STAFF REPORT

REGIONAL CENTER HEARING EXAMINER - HIGH IMPACT CASE

Case Number	2024-REG-024
Address (approx.)	815 South Meridian Street and 25 East McCarty Street
Location	Center Township, Council District #18
Petitioner	Brian Shapiro, by David Rausch, AIA LEED AP
Zoning	CBD-2 (RC)
Request	Regional Center Approval to provide for updated plans for a proposed seven-story hotel and apartment development (previously approved for a six-story hotel through 2019-REG-107 and 2021-REG-063 and approved for a seven-story hotel through 2022-REG-024), with amenities, including a restaurant, courtyard, and roof-top lounge.

NORTH ELEVATION
Scale: 1/8" = 1'-0"

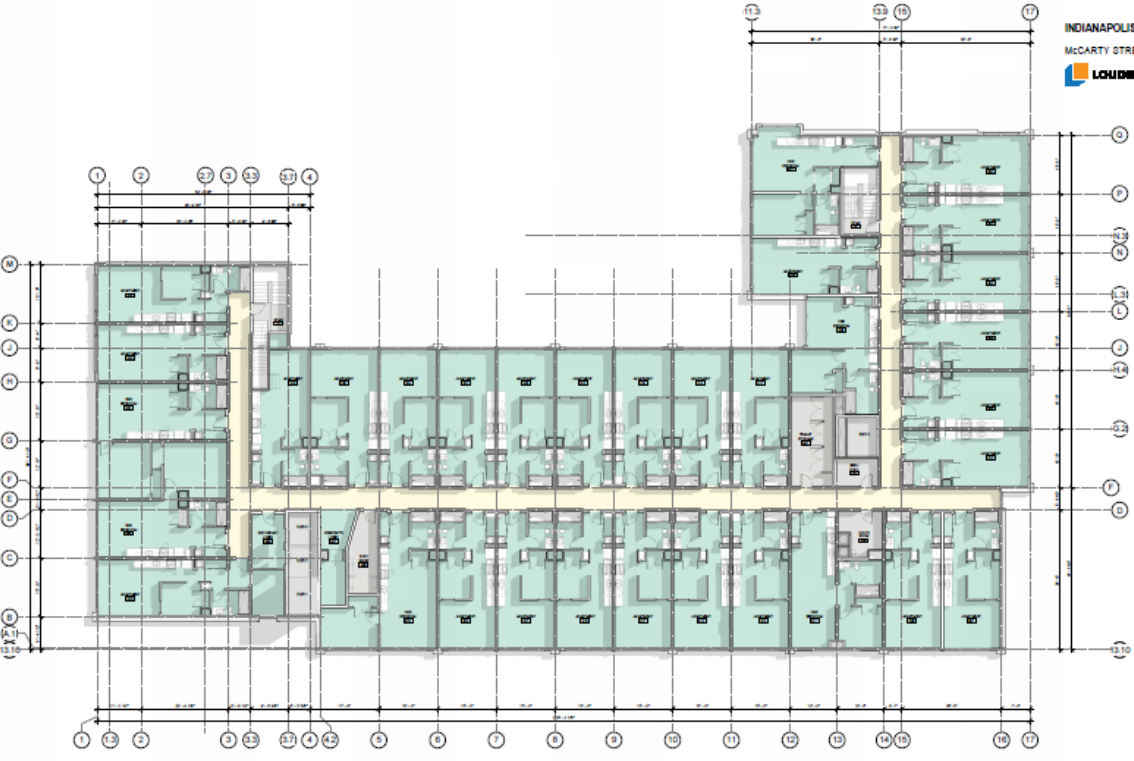
The most significant change would be the eastern portion of the north elevation, where the building would have fewer windows and a more 'solid' appearance. A new, vertical section of windows would project from the façade approximately 18" to 20", which reduces the solid effect. This revised elevation, while providing for fewer windows, would not negatively affect the overall high-quality design of the structure. Another proposed change would be more windows on the northern-most west elevation (Partial West Elevation, below). The previously approved plans provide for a much more solid appearance. This would be an improvement over the approved plans. Finally, a notable change was made by removing balconies from the upper levels of portions of the structure. While this eliminates outdoor space for those units, it would not negatively affect the overall high-quality design of the structure.
